Master Sign Program Revision Conceptual Design Review Board Staff Report

CASE NUMBER: OV314-004
MEETING DATE: February 10, 2015
AGENDA ITEM: 2
STAFF CONTACT: Patty Hayes, Senior Planning Technician
phayes@orovalleyaz.gov (520) 229-4819

Applicant: Paul Blier
Request: Revise Master Sign Program
Location: Oro Valley Marketplace, Tangerine and Oracle Road
Recommendation: Recommend approval of revised Master Sign Program

Existing rear building elevations currently void of signs

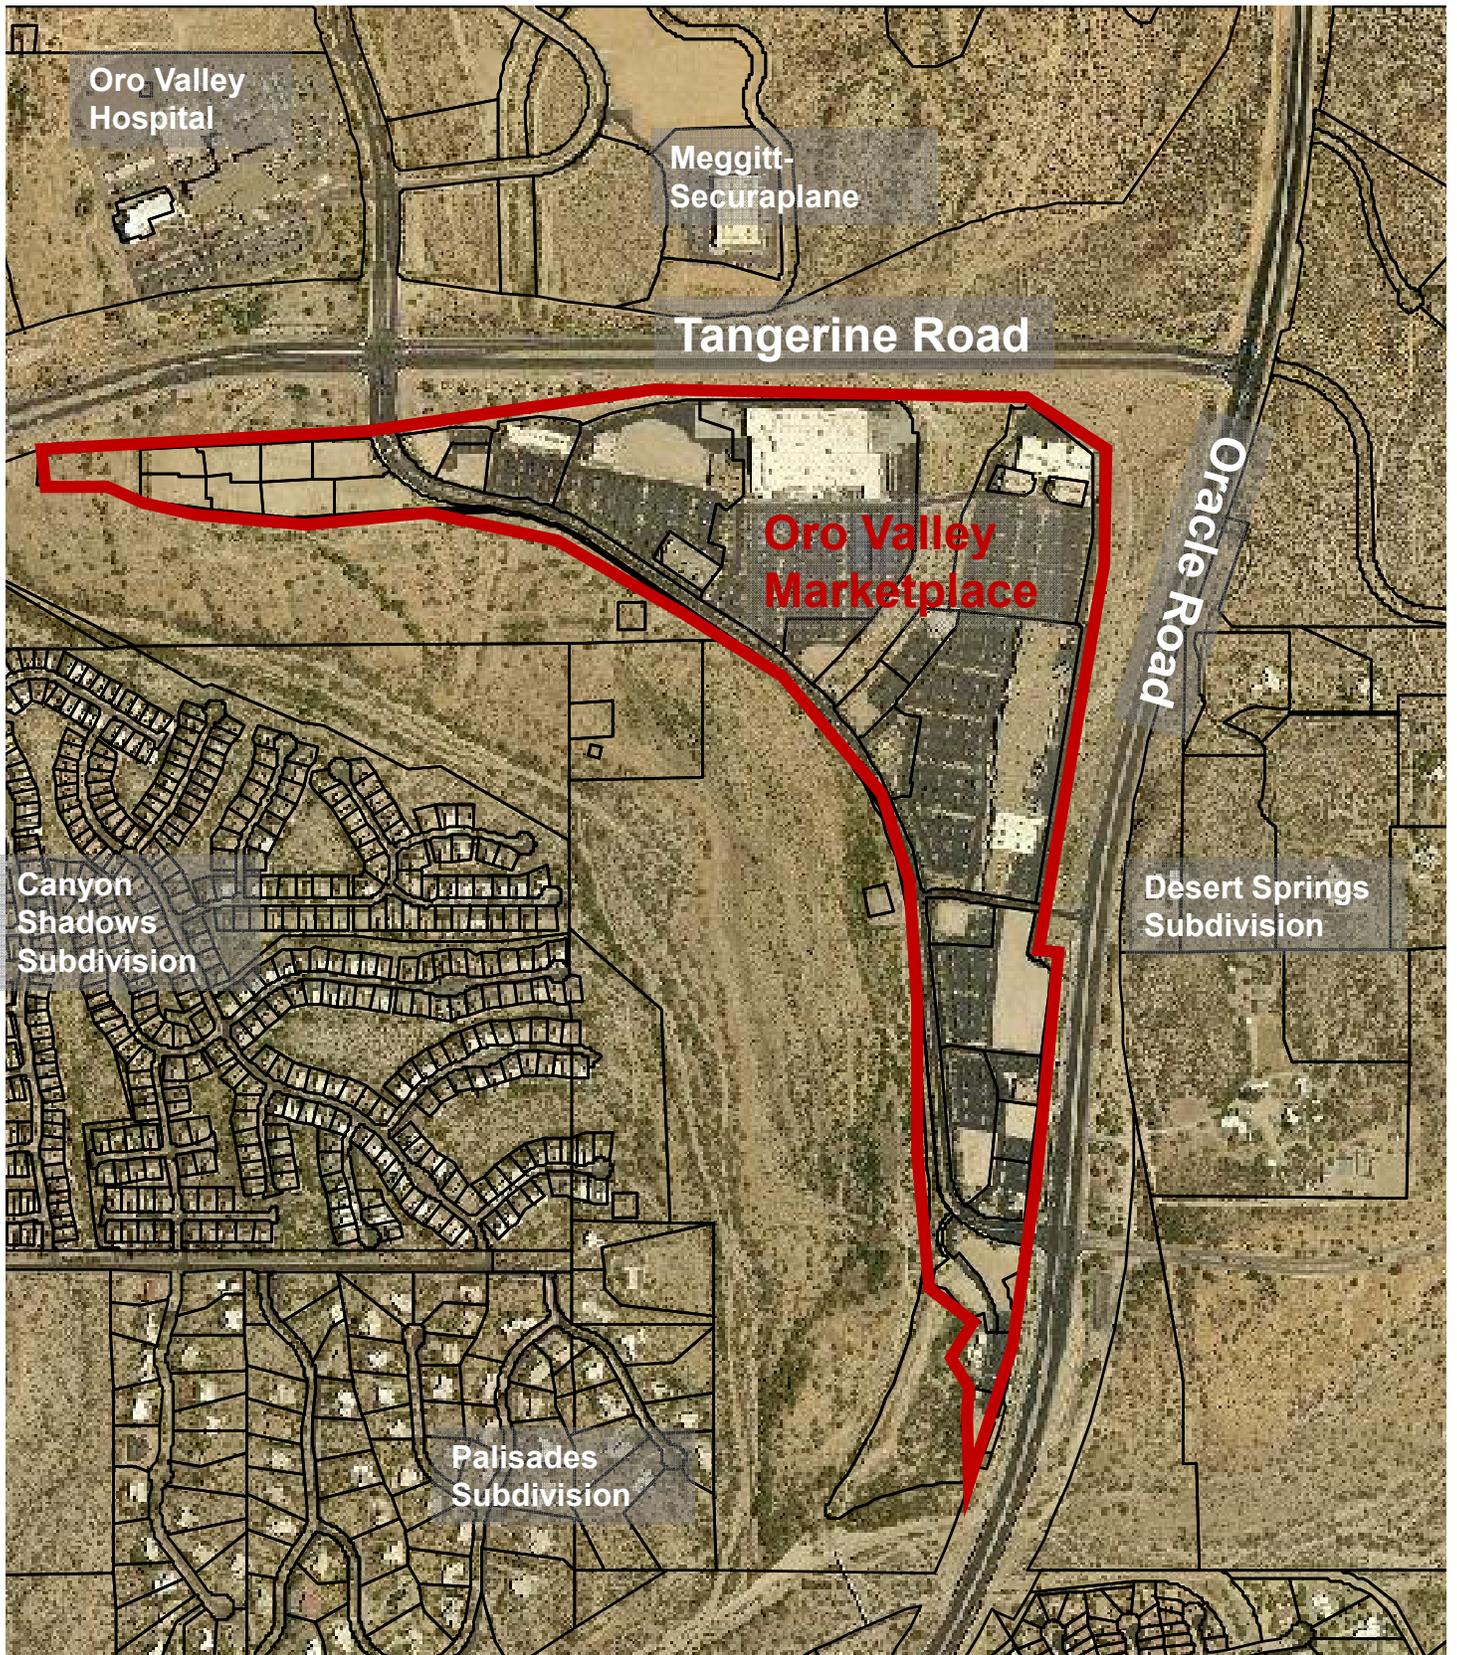
The buildings provide facades (Attachment 3) facing Oracle and Tangerine that could readily accommodate wall signs without changing the architecture of the buildings. The proposed MSP revision will not affect the previously approved sign color palette which meets the current Zoning Code standards.
